# **City Council**

**DATE:** September 10, 2020

FROM: Councilor Pam Wright

**RE:** Comments on the Planning Department's revised provisions of the Residential

# 3.2.7. DuplexTwo-Unit Residence

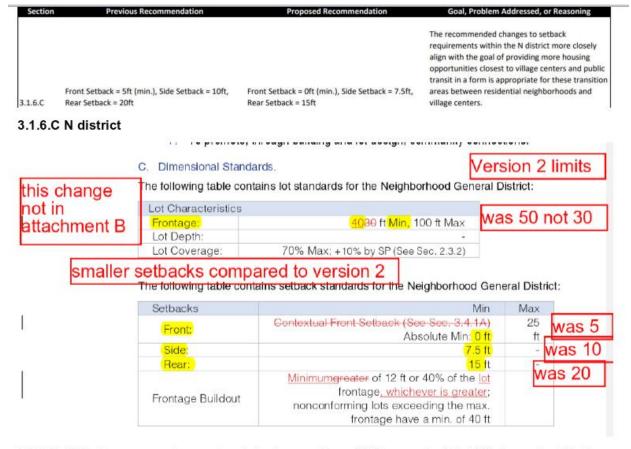
Issue with data in 3.2.7.B. This is for the duplex -changed the max number of stories. It was 3 in version 2 and 2.5 in version 3 but nowhere did it say it changed.

36	3.2.6.B	Ranch size decrease	Why did ranch go down in size and why isn't there one by right in R2?	Explanation and discussion
37	3.2.6.B	Ranch in R3	Why not ranch in R3? Special permit? In case someone wants to build a family compound.	Discussion
38	3.2.6.E.2	2 units in ranch	Allowing 2 units to be built in house D will increase teardowns; per data collected whenver possible developer built 2 units	Discussion
39	3.2.7.B **	Building Dimensional Standards	Marked up building dimensional standards is NOT in the previous table. The previous one has 3 stories for 2 unit. Now it's 2.5 stories and no change log NOW	Update change log
